UN/SCETDG/50/INF.7/Add.3
UN/SCEGHS/32/INF.5/Add.3

**Issues relating to the Globally Harmonized System
of Classification and Labelling of Chemicals: Use
of the Manual of Tests and Criteria in the context
of the GHS**

**Revision of the Manual of Tests and Criteria:
Part II: (Sections 20 to 28)**

**Transmitted by the Chairman of the Working Group on Explosives on
behalf of the Working Group**

Figure 20.1-(a): FLOW CHART SCHEME FOR SELF-REACTIVE SUBSTANCES AND ORGANIC PEROXIDES

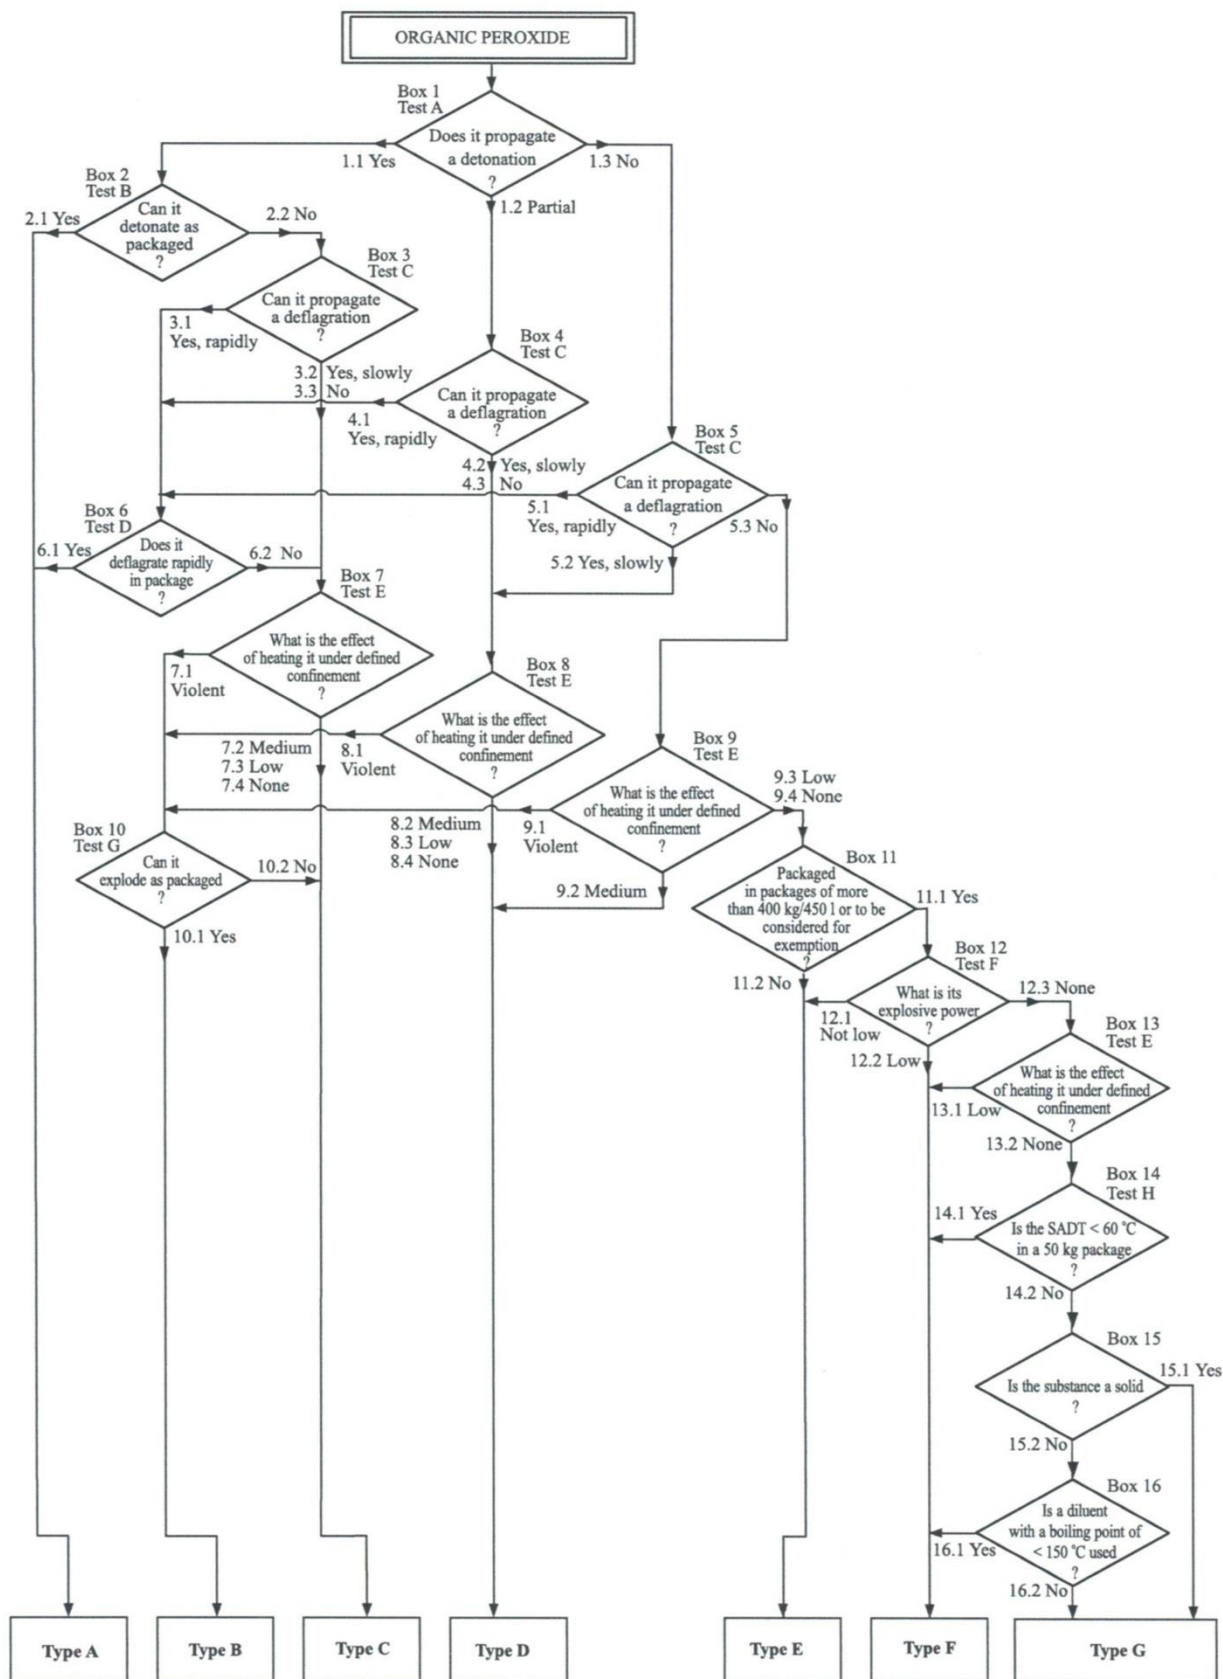
Figure 20.1 (b): ~~FLOW CHART SCHEME FOR SELF-REACTIVE SUBSTANCES AND ORGANIC PEROXIDES (cont'd)~~

Figure 20.3: CLASSIFICATION OF TERT-BUTYL PEROXYBENZOATE

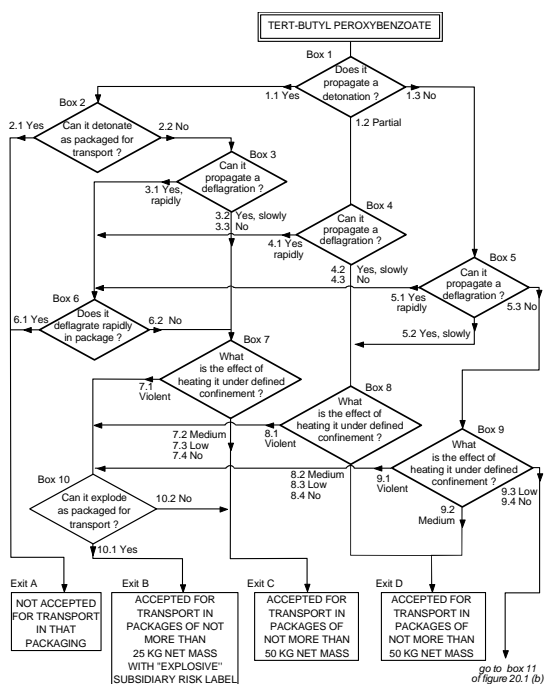
In box 2 and 10: remove the words “for transport”
In box 6 replace “in package” by “as packaged”
Replace “Exit A” to “Exit D” with “Type A” to “Type D”
Remove boxes under the “Exits”
Remove the words “of figure 20.1 (b)” to the reference “go to box 11”

Note by the secretariat: The Sub-Committee is invited to consider whether the proposed reference “go to box 11”, should be amended to read “go to box 11 of figure 20.1” as there is no box 11 in figure 20.3.
